Appendix 5

Addendum

SR 520
SR 520 BIKE PATH - BELLEVUE TO REDMOND

Addendum No. 1

RANDOM BOARD FINISH (PANEL)
STRUCTURAL EARTH WALL #1
N.T.S.

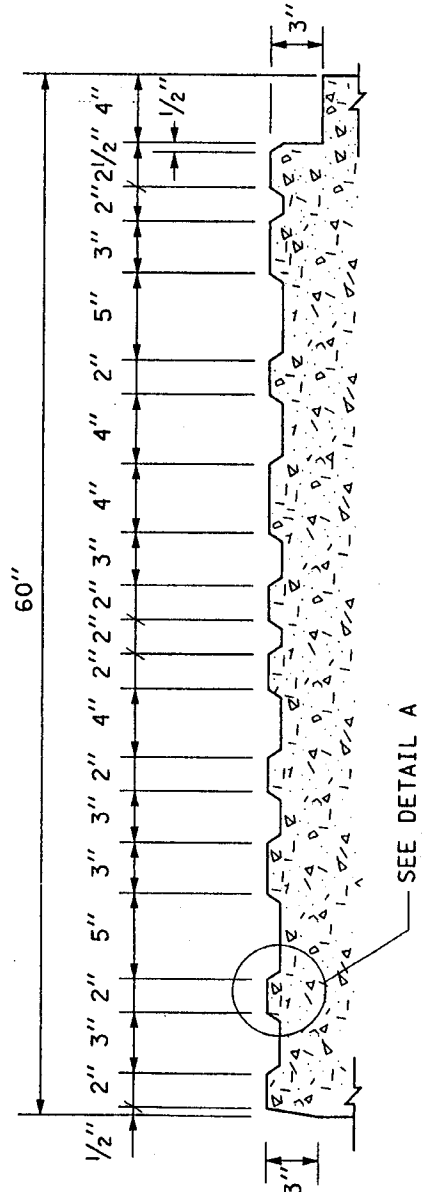
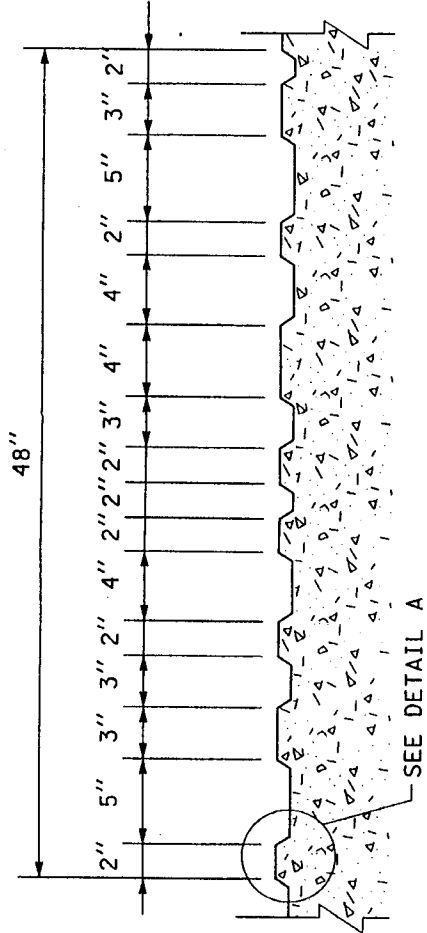
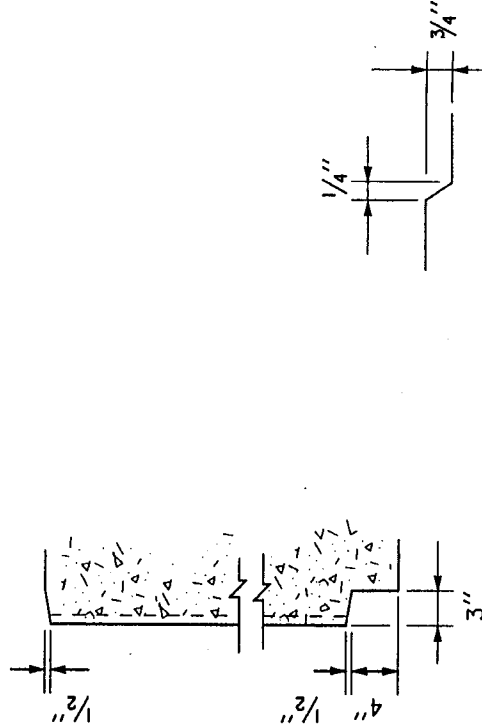
1. Plan sheets 1, 5, 11, 12, 14, 16, 78, 79, of 104 are revised as shaded and noted on the attached sheets.
2. Plan sheets 17A, 17B, and 79A are new sheets.

Wooden forms shall be used to create the random board finish for the Concrete Retaining Wall surface and elastomeric form liners or an ABS or plastic form liner shall be used to create the random board finish for the Structural Earth Wall Panels.

The 3/4 inch random board finish for concrete surfaces specified in the Plans to receive such a finish shall be achieved with reusable wooden forms conforming to Section 6-02.3(17)J and the texture pattern shown in the Plans. ABS, plastic, or elastomeric form liners shall not be used.

The texture pattern shall be accomplished with 3/4 inch thick battens in varying widths applied to the surface of the forms. The edge of all battens shall be sloped 15 degrees to facilitate form removal.
